Zoning Commission

PUD Stage 2 & 3 Revised Site Plan

Burger King

MEETING DATE: December, 19, 2019
TO: WCRPC Executive Committee
FROM: Robert Ware, Subdivision Specialist
SUBJECT: Revised Neyer PUD Stage 2 Plan for a Burger King restaurant

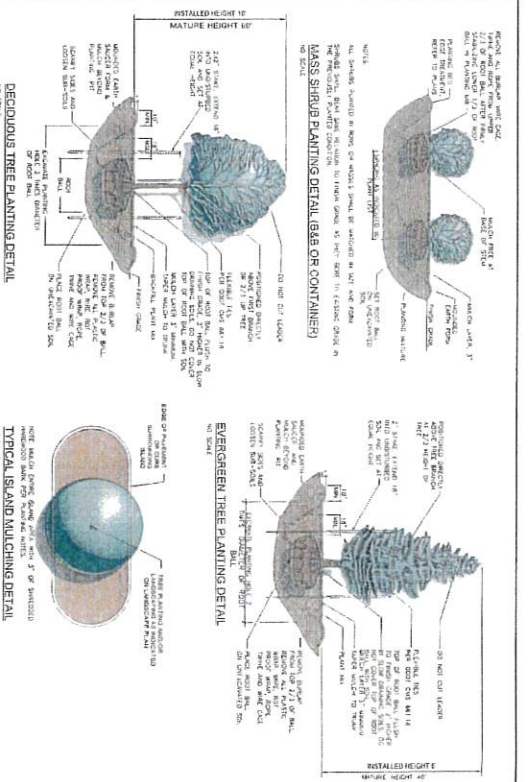
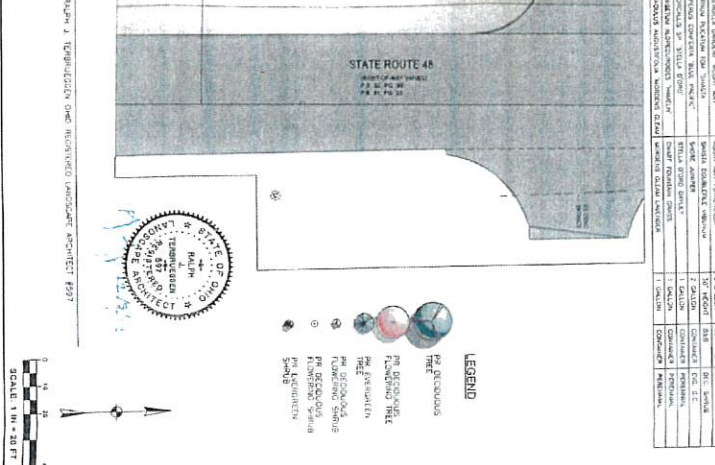
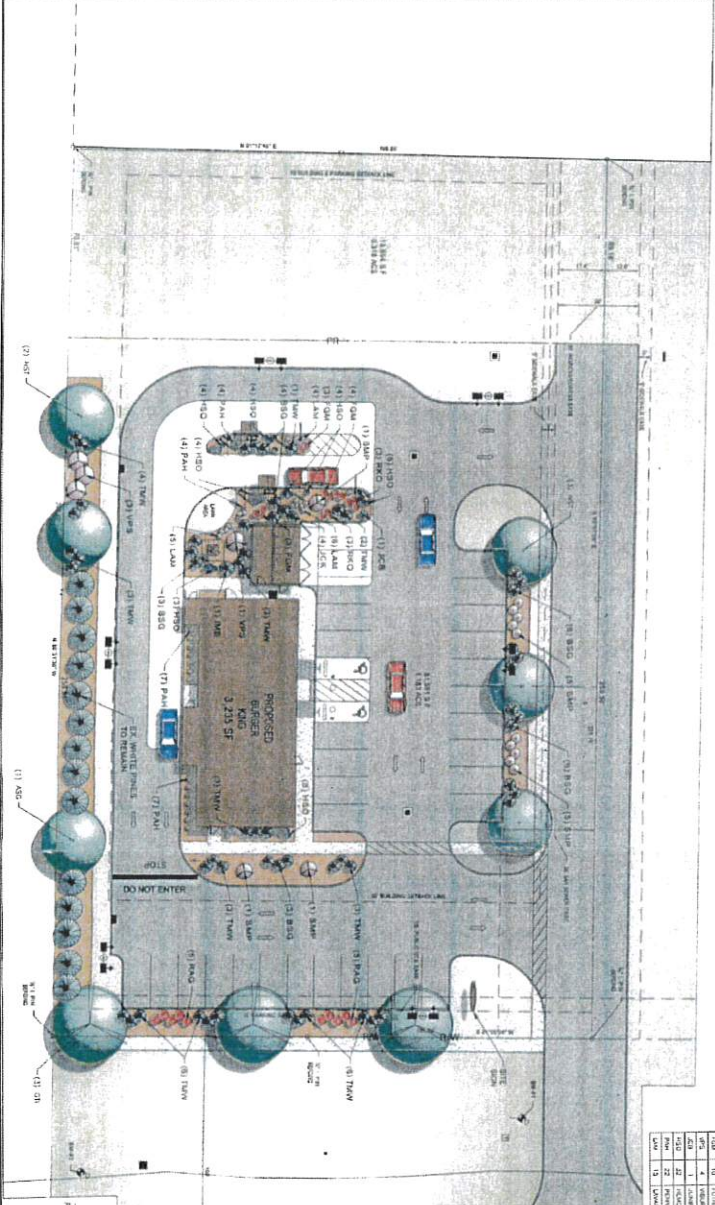
Site lighting will be LED type. The illumination intensity along a portion of the southern boundary is higher than allowed. South Lebanon Elementary School is an Institutional Education facility, which means illumination levels cannot exceed 1.0 footcandles at the property line, and currently plans show two different locations where illumination goes from 1.1 to 1.8 illumination. (See attached Illumination Plan sheet).

The proposed lighting satisfies Zoning Code requirements, except the illumination intensity along a portion the southern boundary is higher than allowed. The Township Trustees should address this matter at PUD Stage 3 and possibly mitigate the lighting impact with by a redesign of the lighting fixtures.
